ECN/PCN No.: R0490

Product Description: 2.4 / 5 GHz Whip Antenna	Abrakon Part Number / Part Series: APAMBJ-135	☐ Documentation only ☒ ECN ☐ EOL	☐ Series ☐ Part Number
Affected Revision: A	New Revision: B	Application:	☐ Safety ☒ Non-Safety

Cause/Reason for Change: Updated test data and ordering information

Reflection Characteristics – Return Loss & VSWR

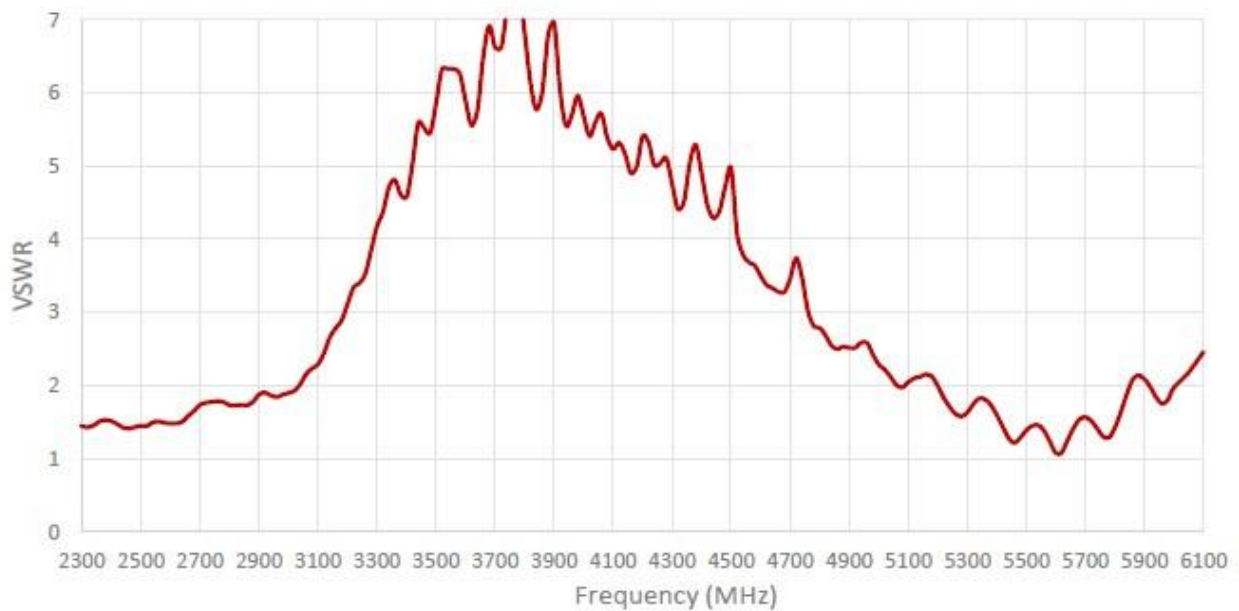
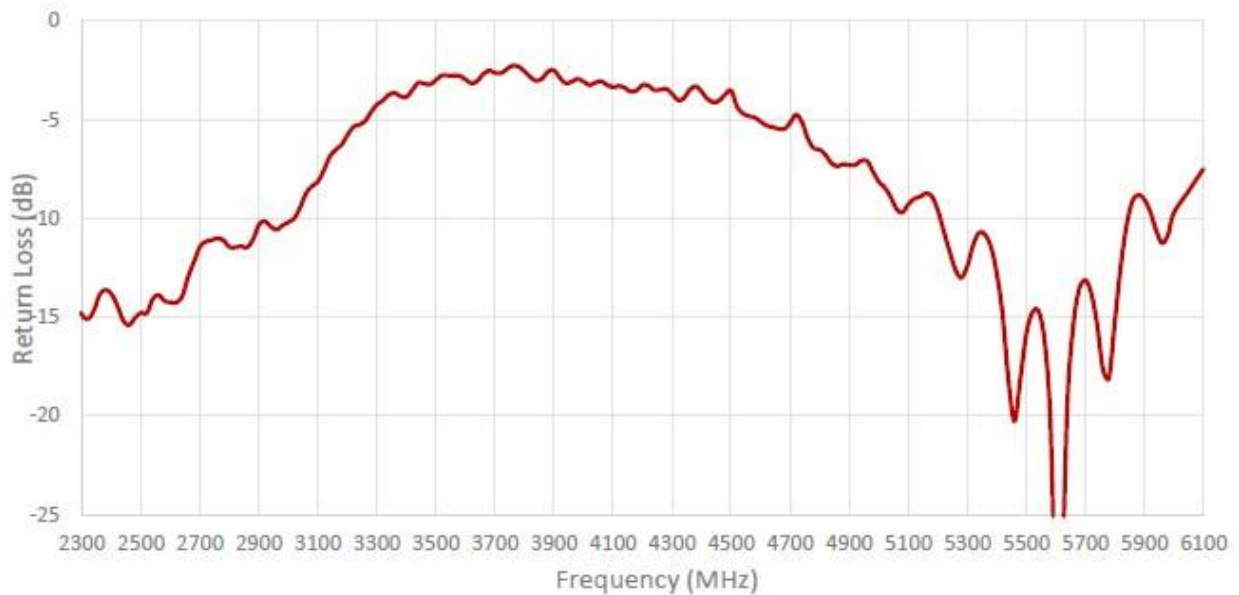
Updated test data
